PEDRO FALCON CONTRACTORS, INC.

Request for Change Order

Project: Glynn Archer Gym

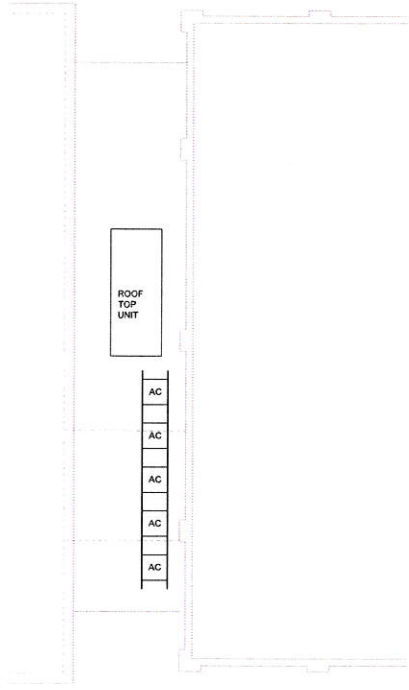
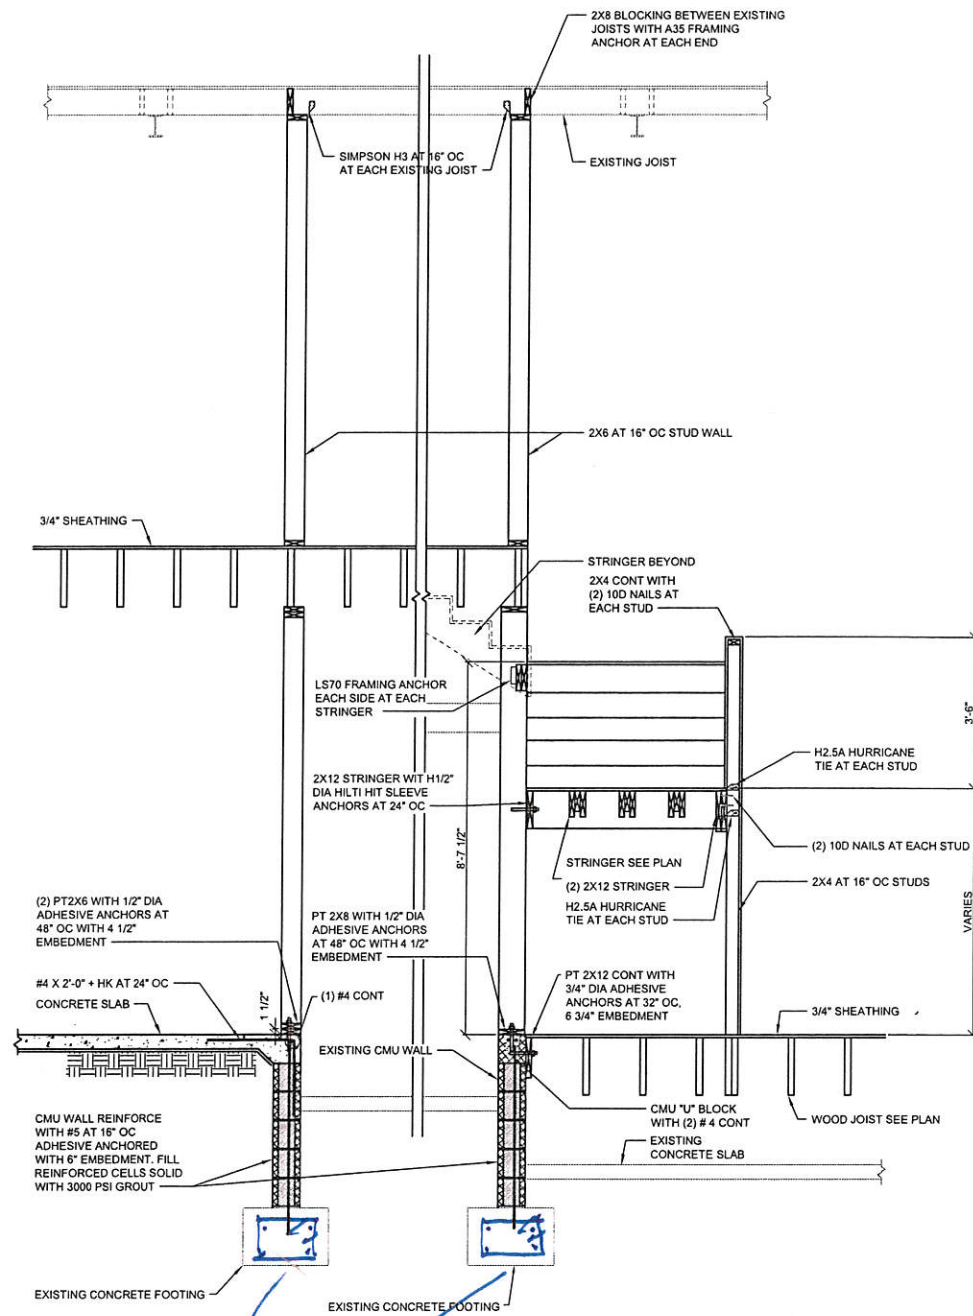
Note 2 from the "First Floor Plan" calls for an 8" CMU wall with #5 at 48" OC drill and adhesive into existing footing with 6" embedment. Unfortunately, approximately 4'-0" does not have any existing footing to install the 8" CMU stair retaining walls onto. Enclosed are three pictures and a part plan showing these two locations. Can you please provide direction on how to proceed or provide a footing detail to support these walls?

approximately 4'-0" does not have any existing support foundations.

No support foundations for the new 8" CMU Wall

No support
foundation for the
new CMU wall on
both sides

No support
foundation for the
new CMU wall

Reply: These walls will require a new 2'-0" x 1'-4" concrete footing with 4-#4 continuous and #3 ties at 2'-0" O.C. (see attached marked up S-2.3).

SECTION 207
SCALE: 1/2" = 1'-0"

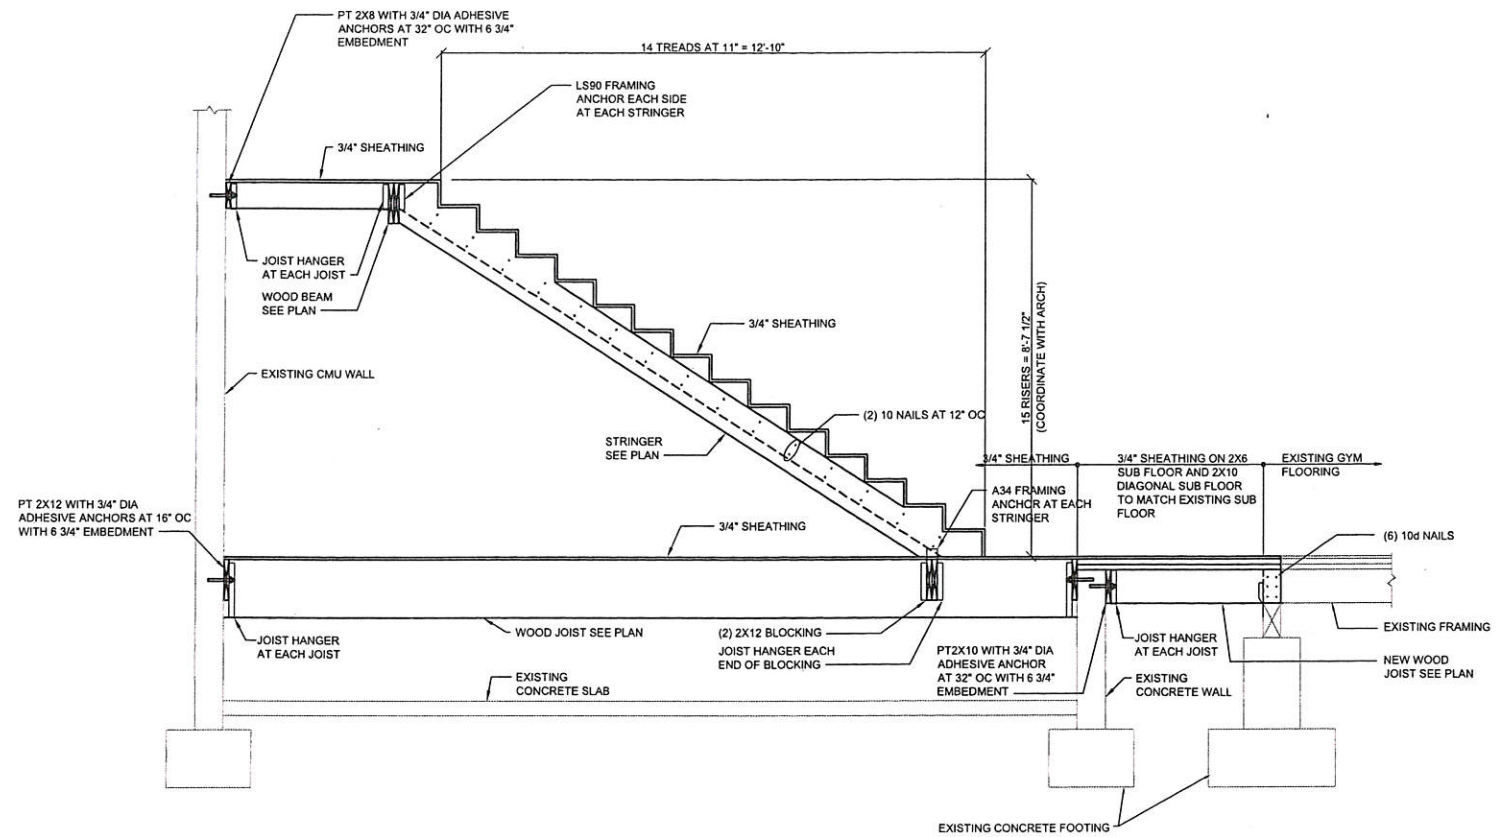
New 110"x14" concrete footing w/ 4-#4 cont. of #4 bars @ 1'-0" O.C.

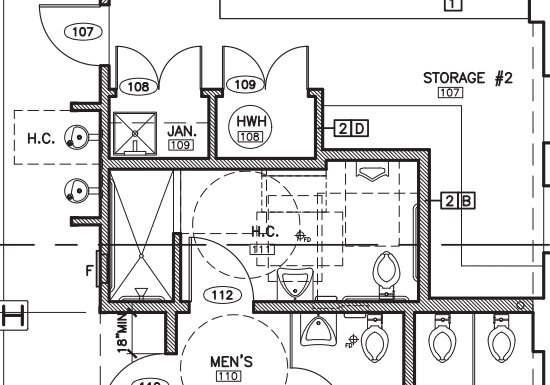
Description: As requested by City representative, Contractor to remove and install a new door at north side storage room, including transplanting bushes and new sidewalk. (see enclosed sketch).

New sidewalk and stoop

New 4 panel fiberglass impact door
